PROJECT NAME: ALIEN ENGINEERED PRODUCTS SHOP EXPANSION

PROJECT NUMBER: 2025050081

APPLICATION: MAJOR SITE PLAN #32920

PAVING, GRADING, AND DRAINAGE PLAN

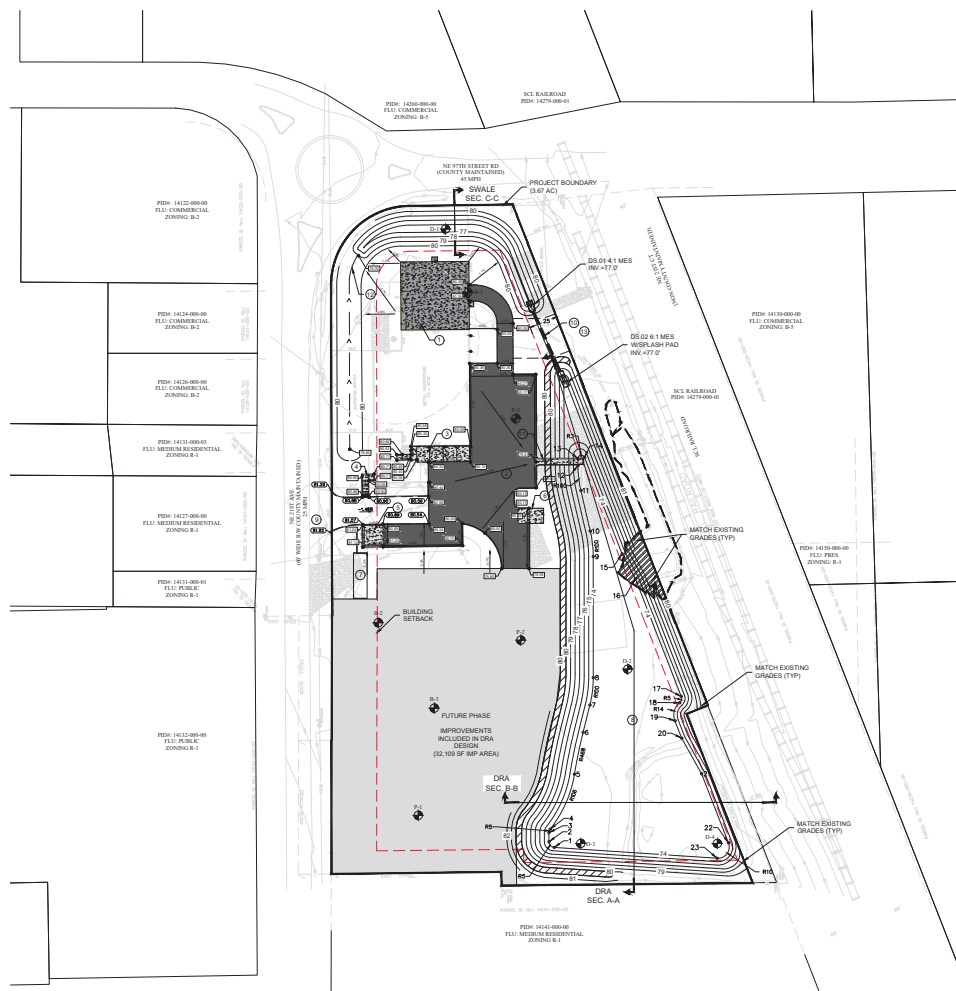
REMARKS: Retention/detention areas serving commercial lots shall be designed with a minimum berm width of 5 feet stabilized at a maximum of six percent grade maximum around the entire perimeter of the facility.

REMARKS: (1) DRAs are required to maintain 6" of freeboard during the design storm. The top of DRA appears to be 80. Peak stage of the 100-year 24-hour storm appears to be 79.57. Adequate freeboard does not appear to be provided. (2) DRA stage during design storm will spread to adjacent CSX property. Please provide written approval for this design from CSX.

REMARKS: DRAs greater than 4' deep require the bottom to be sodded in addition to the side slopes.

Section & Title of Code (be specific) 6.13.2.B(6) - Freeboard 6.13.2.B(6) - Freeboard
Reason/Justification for Request (be specific): 1) A Waiver is being requested for the 6" of freeboard to the top of bank. The previously approved design and code requirements do not appear to have considered freeboard in 2000.
Proposed design increases capacity such that freeboard is increased from 0" to 5.6" (86% of today's code) to the top of DRA.
Existing conditions creates additional burden for full compliance and design will greatly improve system capacity.
